FINAL RECOMMENDATION OF THE QUEEN ANNE/ MAGNOLIA DESIGN REVIEW BOARD

Project Number: 3012582

Address: 223 W Galer St

Applicant: Via Architecture for Aegis Living

Development Option 3 (Preferred)

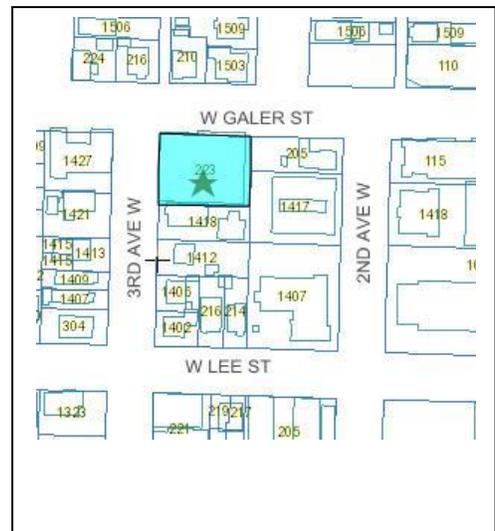
The third scheme (Option C) showed an option where the Memory Garden was moved back to the south side and the driveway and loading dock were both located on 3rd Ave W. Bay window elements were shown along W Galer St and a cornice line was incorporated above. Massing diagrams of this preferred scheme are shown below.
